## Determination 2009/112

# Refusal to amend a building consent regarding damp proofing to a basement of a house at 75A Awatere Avenue, Hamilton

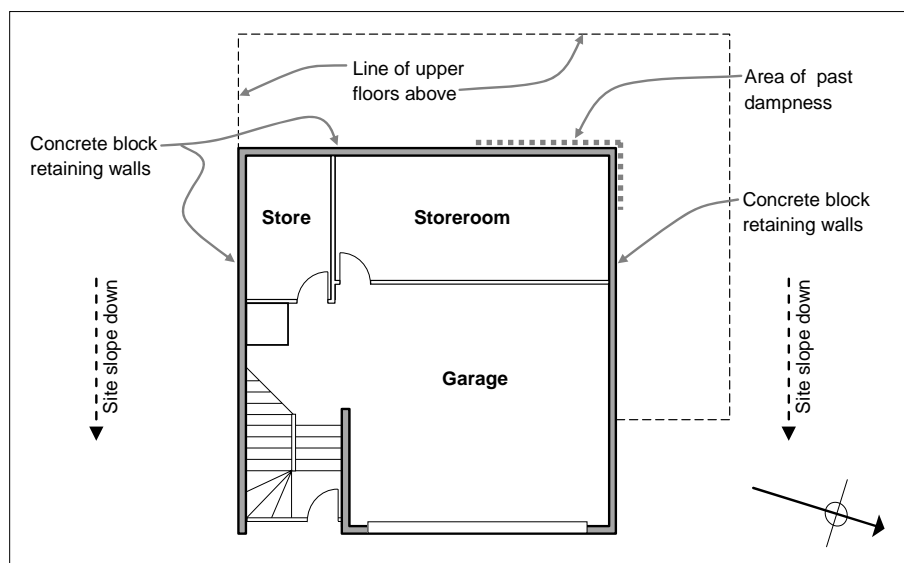
- 2.1 The building work covered by the original building consent consists of a three-storey house on a site that slopes steeply towards the street.
- 2.2 The basement level of the house accommodates a double garage area and two storerooms; and is set into the slope of the site, with a concrete slab and foundations, and reinforced concrete block retaining walls to three sides as shown below:

- 2.3 The consent documents call for damp proofing to the exterior of the retaining walls to be provided by a brand-named composite membrane incorporating a bentonite compound, which is protected by a layer of brand-named geocomposite vertical drainage blanket.
